REGENCY TOWER

10-18 RECENT STREET, WOLLONGONG

From: Louise Wells [<mailto:Louise.Wells@planning.nsw.gov.au>]
Sent: Wednesday, 8 October 2014 10:28 AM
To: Anne Starr
Cc: Graham Towers
Subject: RE: DA-2013/1419 10-18 Regent Street - building height

Figure 2 – West Elevation (architectural roof features shaded red)

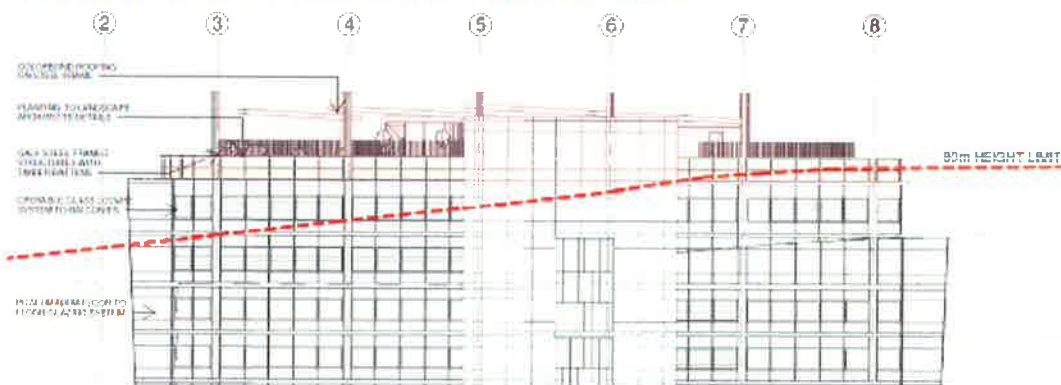
The roof features include the sweeping balustrade, pool terrace and lift shaft. All these features are integrated into the building and will not be able to be converted into floor space. Overall, the proposed roof features align with the above four criteria and are illustrated in the images below.

Figure 3 – North Elevation (architectural roof features shaded red)

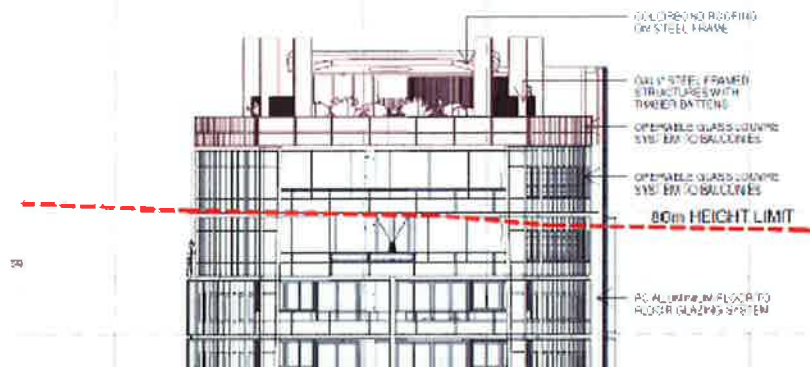
As detailed in Figure 3, the maximum height non-compliance of 4.49m is located at the north-western portion of the site. This is primarily due to the topography of the site. The steep slope of the site contributes to this northern portion of the development exceeding the height limit. The southern portion of the development is below the height limit of the site, which is evidenced by the Western elevation at Figure 2. In addition to the comments above, it is considered that the following justifications for the variation to the height control on site are worthy of support from Council:
